SDI FINAL EVALUATION FORM 1.1

Journal Name:	Journal of Engineering Research and Reports
Manuscript Number:	Ms_JERR_130296
Title of the Manuscript:	Three New Approaches to estimating Energy Losses in Stepped Spillways with the Channel slope of 8.9o.
Type of Article :	Original Research Article

Check of Figure 5  Legend: - Measured Data Run1 - Power (Developed Model-1) - Series1 - Reviewer's plot of Model-1 - Power (Series1)		What is the formula that you used for this plotting?
--	--	---

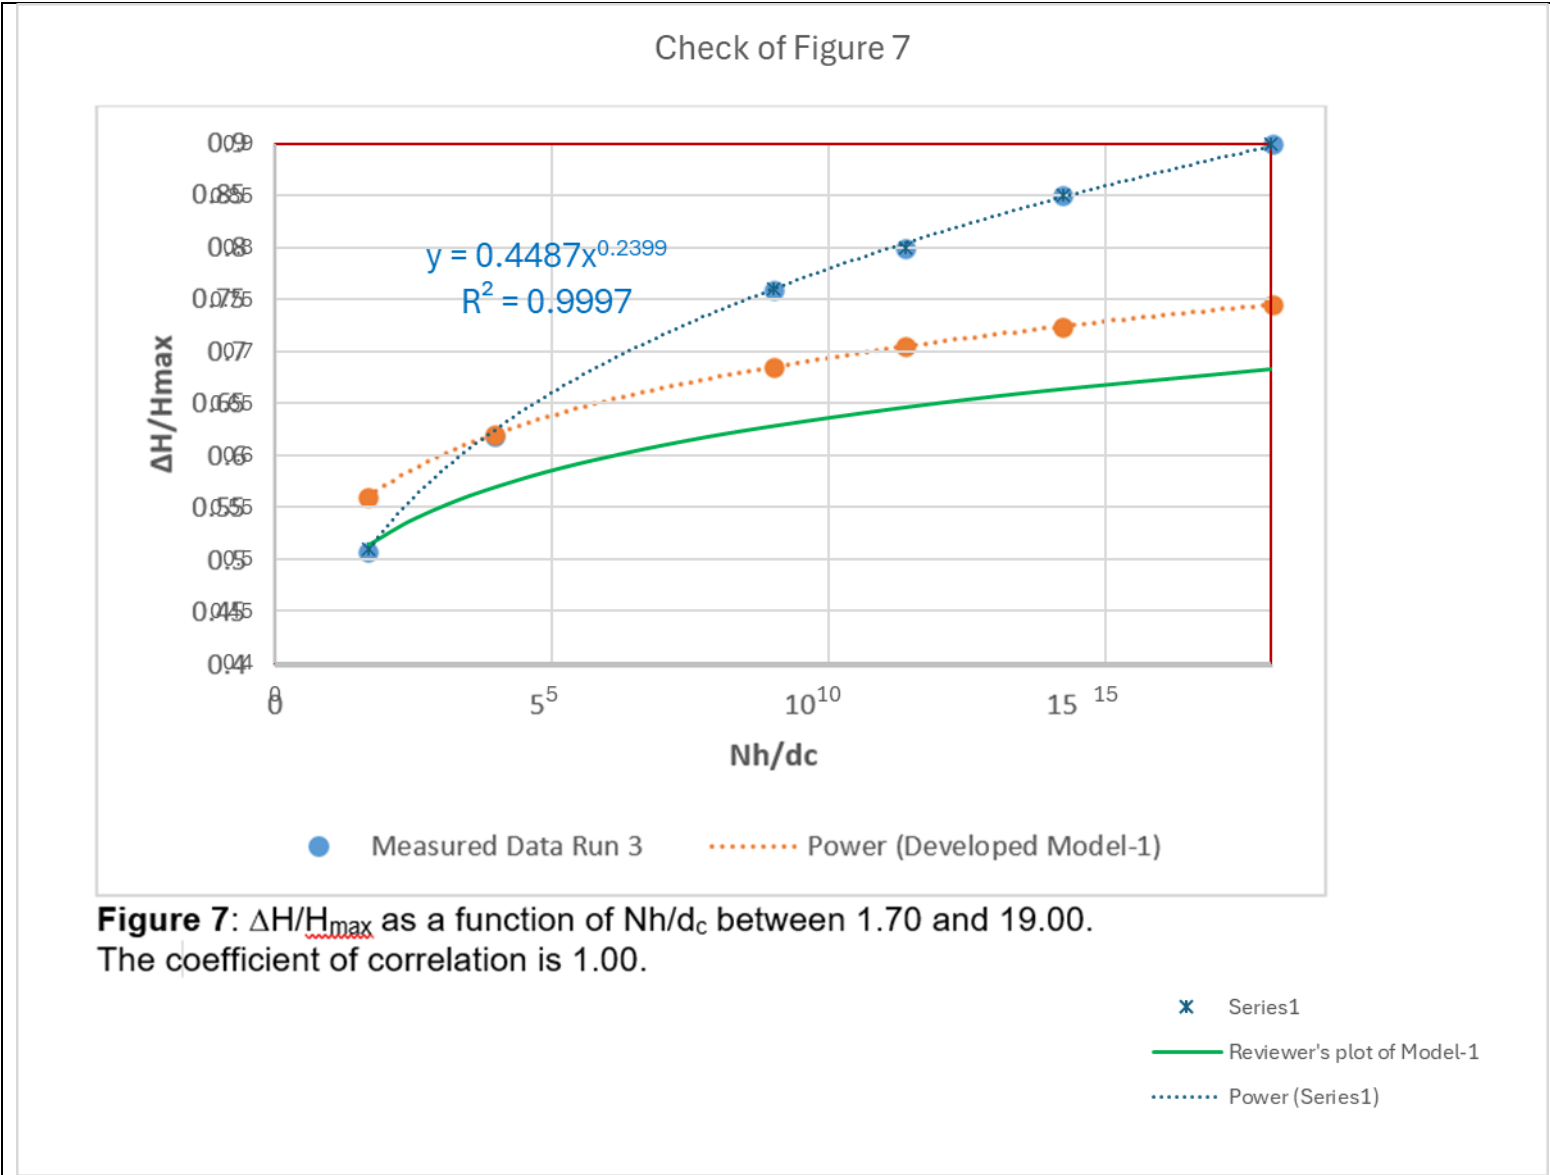
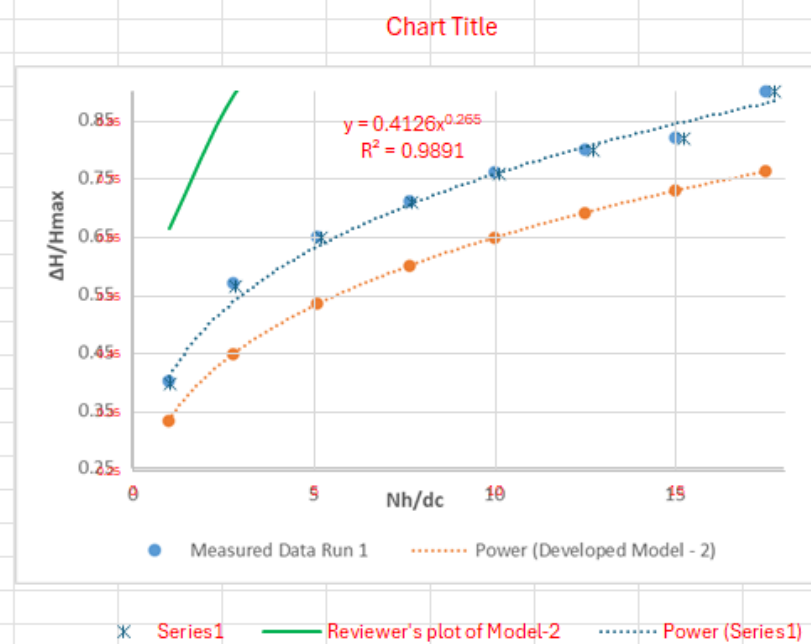
What is the formula that you used for this plotting?

What is the formula that you used for this plotting?

0.05	0.0046 works much better to match their curve
0.29	
0.2	
-0.17	
-0.3

For this plot, changing the 0.05 to 0.0046 produces a better match of the equation to the author's plotted curve, but their curve still does not match the observed data.
